Ν	U.S. DEPARTMENT OF COMMERCE NATIONAL OCEANIC AND ATMOSPHERIC ADMINISTRATION NATIONAL OCEAN SERVICE
۵	DESCRIPTIVE REPORT
Type of Surv	vey HYDROGRAPHIC
	OPR-0309-KR
	. H-11100
	LOCALITY
State	ALASKA
General Loc	cality GULF OF ALASKA
	cality GULF OF ALASKA APPROACHES TO ICY BAY
	APPROACHES TO ICY BAY
	APPROACHES TO ICY BAY 2002 CHIEF OF PARTY
	APPROACHES TO ICY BAY 2002 CHIEF OF PARTY DEAN MOYLES

Project: OPR-O309-KR Sheet Letter: "B" Registry No.: H11100

Revisions Compiled During Office Processing and Certification

Figure 3 Histogram for 8101 (QuickSilver)

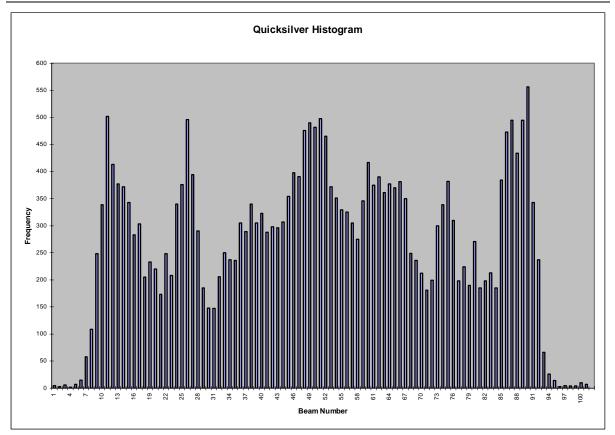
The first histogram is for the Reson 8101 data collected from May 23, 2002 to July 15, 2002 on the Quicksilver. This histogram shows a number of distinct features, one being the valley around the nadir beams. This is a result of nadir penetration, which is a common feature with Reson 8101 data. This is a result of having the power high enough to receive an accurate detection on the outer beams as well as being a function of bottom type. The majority of lines collected had a noticeable sample of nadir beams that had deeper depths than the surrounding soundings. These typically did not have any significant structure and were flagged as noise in HDCS. Since these were rejected, soundings from the adjacent beams were selected instead causing the spikes around beams 46 and 55.

The valley around beams 31 and 70 is the result of the survey line pattern. As the lines were run, port beams overlapped with port beams and starboard beams overlapped with starboard beams from the adjacent lines. This makes it possible to have higher density data per square meter on the outer edges, leading to a higher chance of sounding selection on the smooth sheet. Superimposed on these examinations is the transition from phase to amplitude detection method of the sonar and any errors due to sound velocity.

Given all of these observations, the distribution is an example of what would be expected using a Reson 8000 series multibeam sonar for a hydrographic survey.¹¹

¹¹ Concur. Chart according to the current survey.

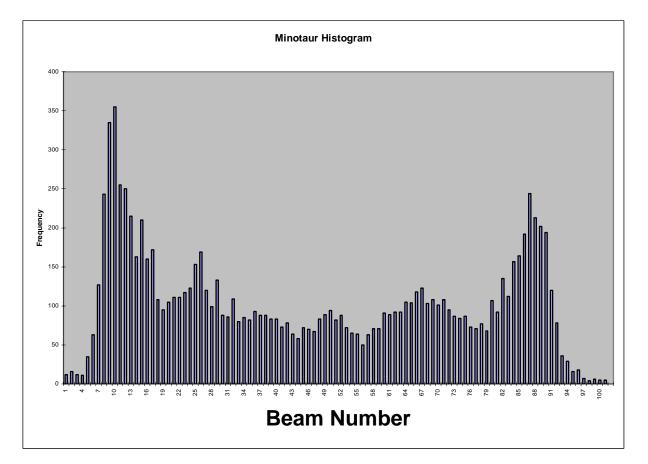
The second histogram is for the Reson 8101 data collected from May 23, 2002 to July 15, 2002 on the Minotaur. This histogram shows a few distinct features, one being around the nadir beams. The majority of lines collected had a noticeable sample of nadir beams that had shoaler depths than the surrounding soundings. This is a result of early bottom detections by the Reson 8101 and was due to having the power high enough to receive an accurate detection on the outer beams as well as being a function of bottom type. The valley on either side of nadir around beams 43 and 58 is the result of a graphical shadow created by the shoaler nadir soundings.

The valley and spikes around beams 25 and 70 is the result of survey line pattern. As the lines were run, port beams overlapped with port beams and starboard beams overlapped with starboard beams from the adjacent lines. This makes it possible to have higher density data per square meter on the outer edges, leading to a higher chance of sounding selection on the smooth sheet. The spike on the port and starboard are the result of surveying near the shoreline. Superimposed on these examinations is the transition from phase to amplitude detection method of the sonar and any errors due to sound velocity.

Given all of these observations, the distribution is an example of what would be expected using a Reson 8000 series multibeam sonar for a hydrographic survey.¹²

¹² Concur. Chart according to the current survey.

Figure 5 Chart Comparison-1

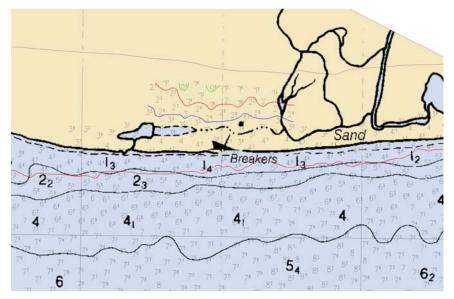
• Hydrographic survey H11100 revealed that the shoreline shown on chart 16741 might be projected incorrectly.²¹ The shoreline provided with the SOW has migrated north of the charted shoreline. This is more predominant on the northwest corner of H11100 and Inset. Due to this shift the soundings and contours do not match with those shown on the chart.²² Although as you move south on H11100 the sounding and contours agree.

²¹ Do not concur. It is likely that the shoreline has undergone considerable migration since last surveyed due to rapid movement of sediments from glacial melt, river runoff, and tidal currents.

²² Concur with clarification. A comparison of the present survey to charted depths shows general agreement (plus or minus 0.5 - 1 fathom) throughout the survey area, with two exceptions. Based on the present survey data and, the evaluator estimates that in the Priest River vicinity, the MHWL has migrated up to 435 meters shoreward with depths up to 4¹/₂ fathoms deeper than charted, and in the Point Riou vicinity, the MHWL has migrated up to 495 meters shoreward with depth increases to 5 fathoms deeper than charted. Refer to the Hdrawing for approximate MHWL revisions and approximate depth curves based on the current survey. MHWL estimations and approximate depth curves were added during PHB processing and were not depicted by the hydrographer.

During PHB processing of H11100 and re-examination of H10985, it was observed that no adjustment had been made to the charted MHWL around Point Riou Spit. Since considerable migration of the spit was found during H10985, the evaluator recommends compiling the MHWL as portrayed on Hdrawing 16741h11.100 to reflect a more accurate charting representation.

Figure 6 Chart Comparison-2

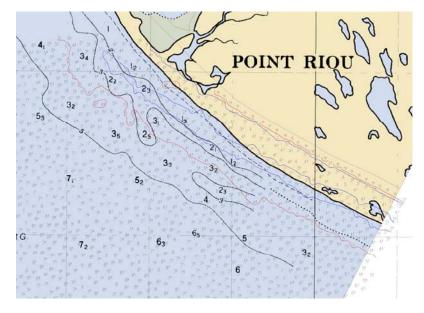
• The same problem is occurring on the east side of Sheet B: the shoreline, soundings and contours have migrated onto the chart.²³

²³ Concur. Strikethrough onto the chart, replace with "shoreward of the charted MHWL." See endnote 22.
